# Illabo to Stockinbingal Response to Submissions

**INLAND  
RAIL**

FIGURE 7-1 INDICATIVE LAYOUT OF A PRIVATE STOCK CROSSING (SUBJECT TO DETAILED DESIGN)

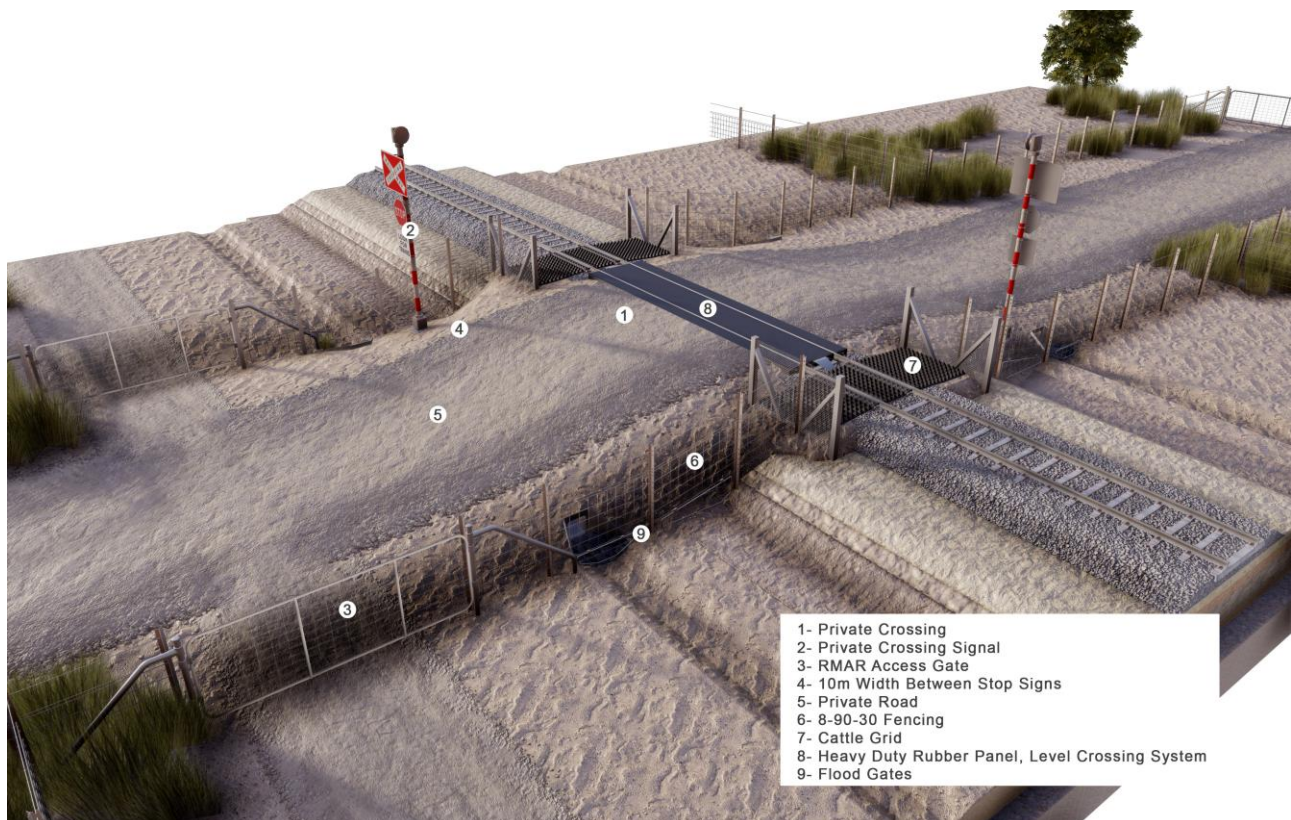
Mitigation measure LP-6 requires that where the creation of the rail corridor would sever a lot that currently has legal access to a public road, access would continue to be provided to both parts of the lot from a public road (or roads). Access across the rail corridor to the severed part of a lot can be provided by a level crossing. However, minimising the number of new level crossings provided as part of the proposal is desirable for safety reasons and is aligned with TfNSW and ONRSR level crossing policies. Access would continue to be maintained, and/or potential impacts managed, by:

ARTC has developed indicative layouts for private level crossings and stock underpasses, these are presented in Figure 7-1 to Figure 7-3. The safe movement of stock and farm machinery across the rail line at private crossings would be considered when developing these typical level crossing layouts. Engagement and discussion with landowners included a review of stock and plant movements.
